PLAN AND ZONING COMMISSION MEETING

Case F22-09: Request of Beckett Place Development, LLC for a Final Plat of Beckett Place for a 51 lot subdivision on 25.8 acres located south of Veterans Memorial Parkway and east of Interstate 74. [Ward 6]

FINAL PLAT

BECKETT PLACE

FP2

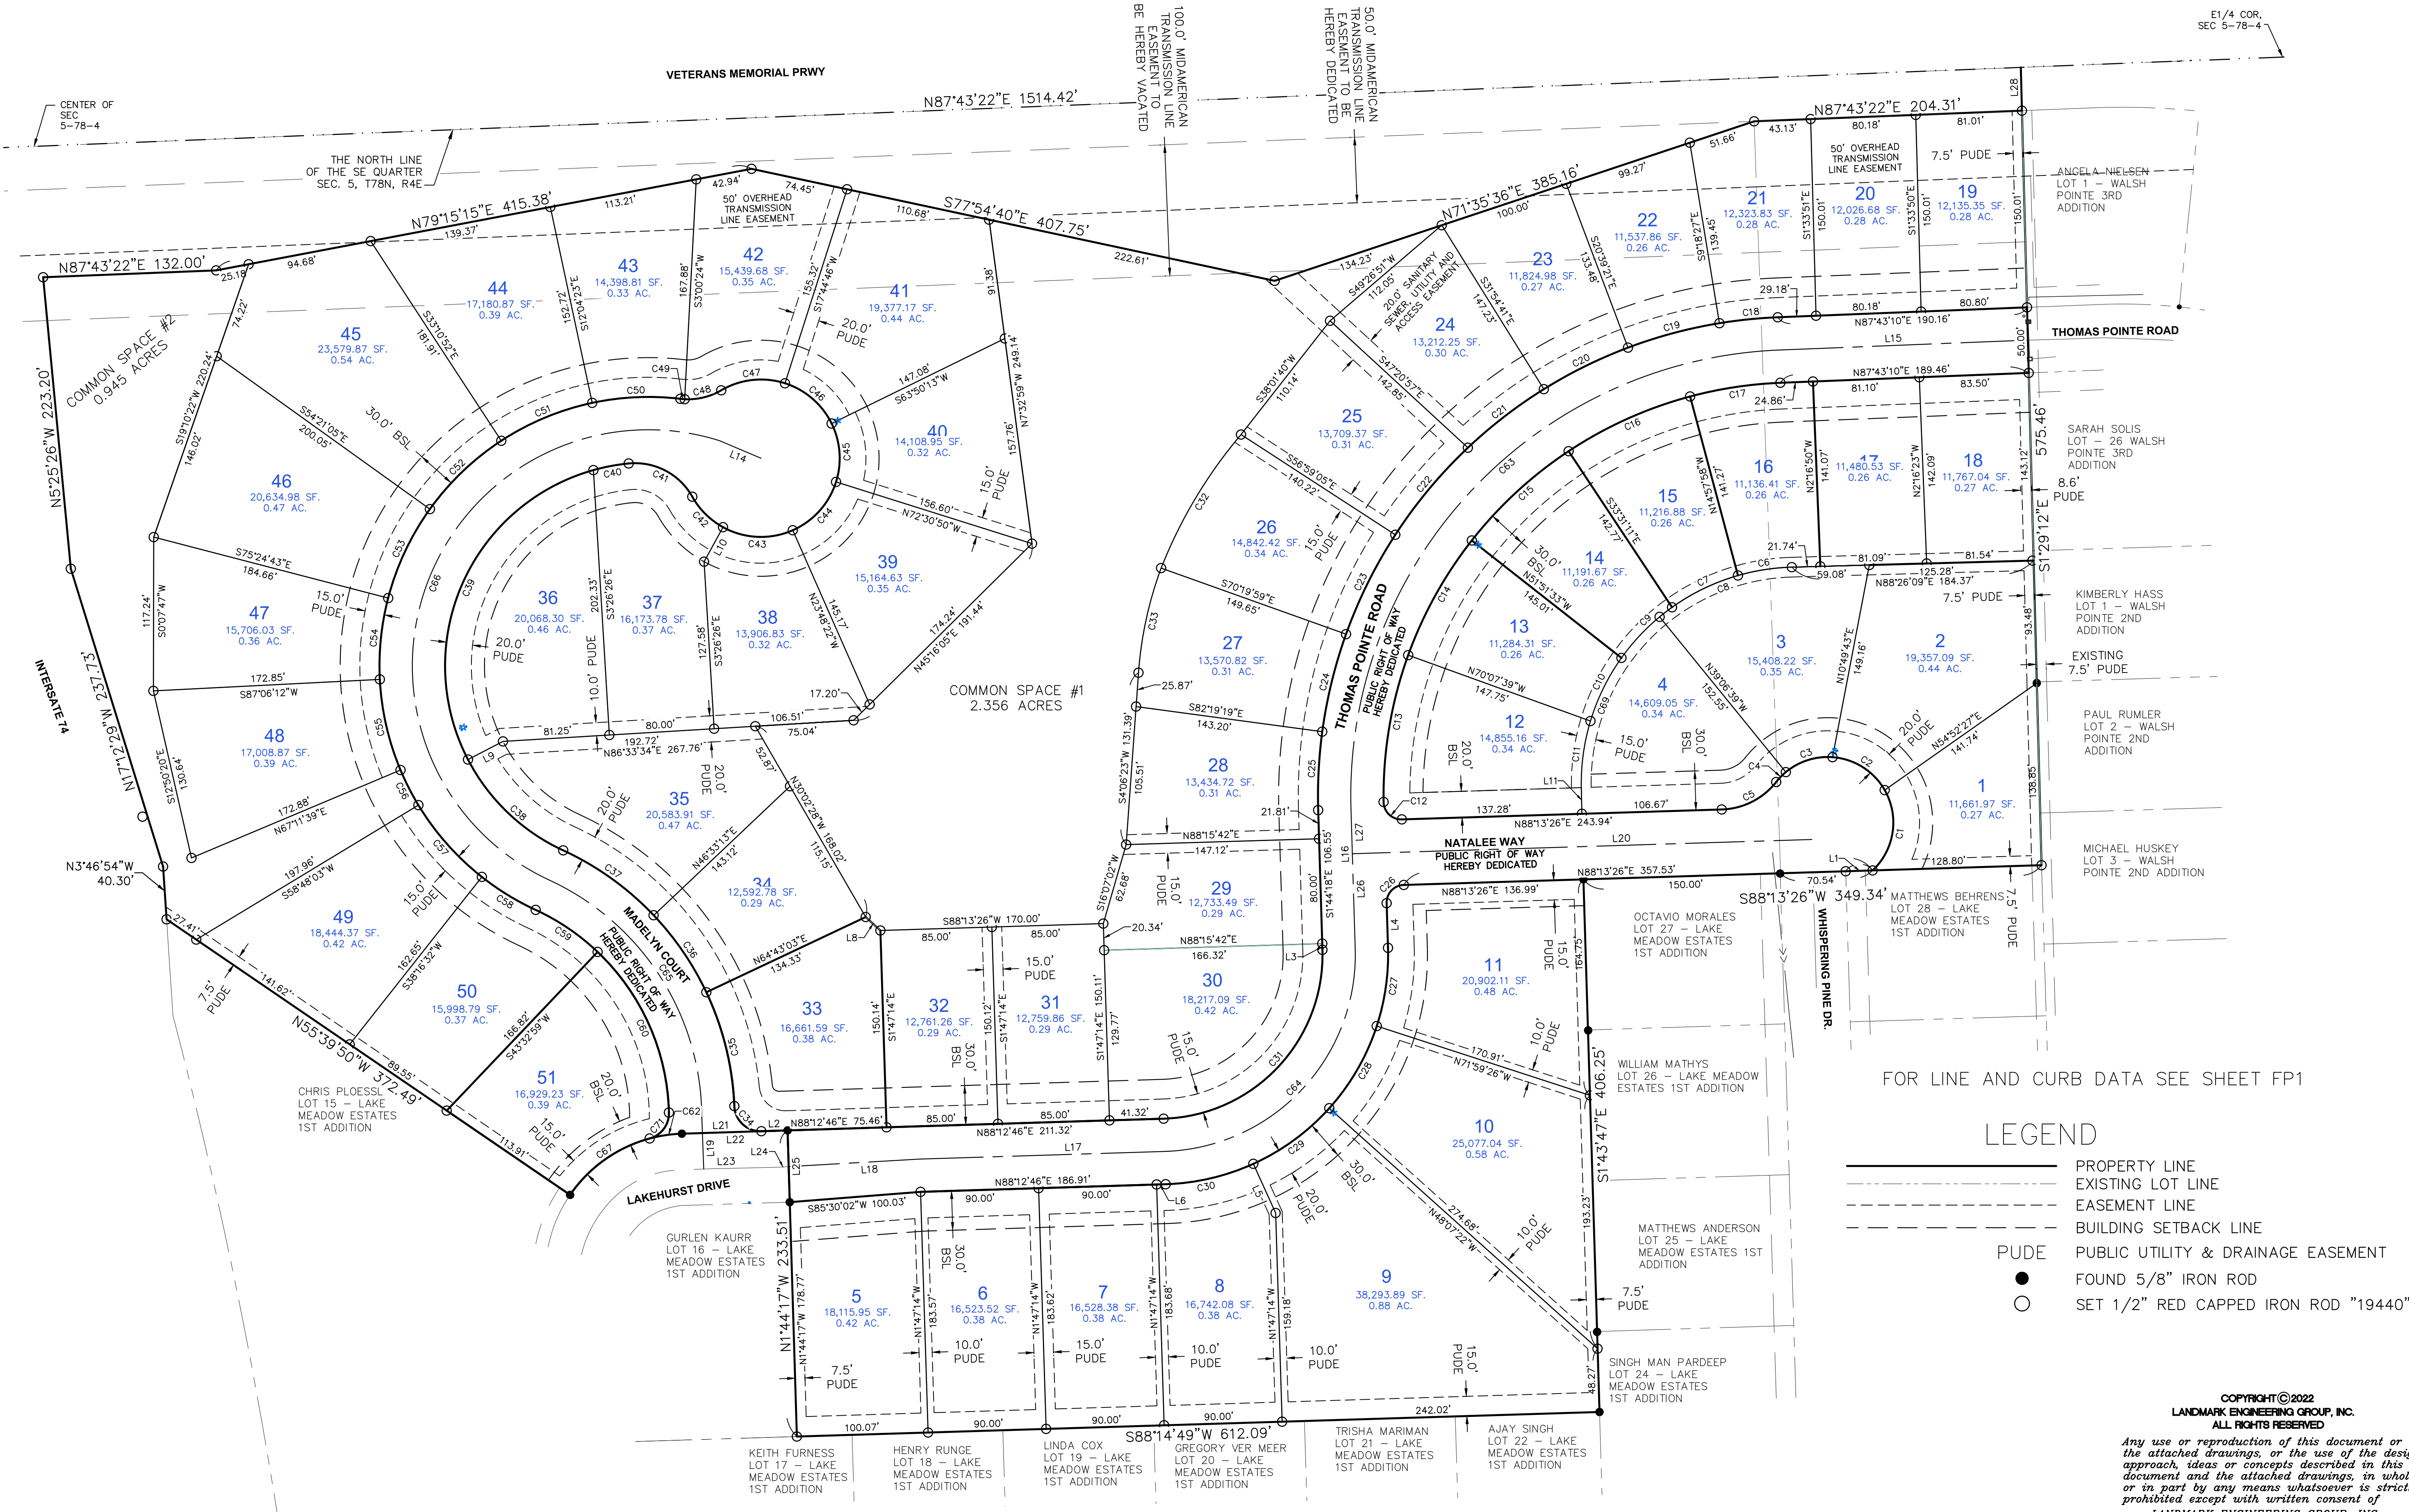
1. That the surveyor signs the plat.
2. That the utility providers sign the plat when their easement needs have been met.
3. A signature shall be added for Metronet.

4. A variance to Section 16.24.040C for a cul-de-sac exceeding maximum length is granted for Madelyn Court.
5. Standard Plat Notes shall be added.
6. Relabel "Common Space #1" and "Common Space #2" as "Outlot 1" and "Outlot 2".

7. Common Space #1 shall be labelled as a stormwater detention easement.
8. Add a note stating, "On-street parking shall be limited to one side of the street. No parking will be permitted within the cul-de-sac."

9. Add a note stating, "Sidewalks shall be constructed along all street frontages prior to the completion of residential construction for each lot, or as so ordered by the City of Davenport."

10. Add a note stating, "Stormwater detention and water quality treatment are required for this subdivision and shall be owned and maintained by the owner or home owners association.

11. All easements shall be a minimum width of 15 feet or twice the depth of the utility line, whichever is greater. All drainage easements shall be a minimum width of 20 feet.

12. Provide full easement widths on Lots 5, 9, 10, and 11.
13. Add allowable low entry elevations to each lot adjacent to drainage ways and the pond.

1. Streets: The standard specifications call for parking on only one side of the street where street width is 27 feet or less. Sidewalks are required along all city right-of-way.
2. Storm Water: The site requires stormwater detention and shall meet water quality criteria in

the Iowa Storm Water Management Manual. Storm detention is proposed in Common Areas 1 and 2, which should be relabeled as outlots. Access must be provided for maintenance of detention areas and any drainage ways must be maintained to provide for the proper flow of water. The full extent of the trail must be located within an access easement.
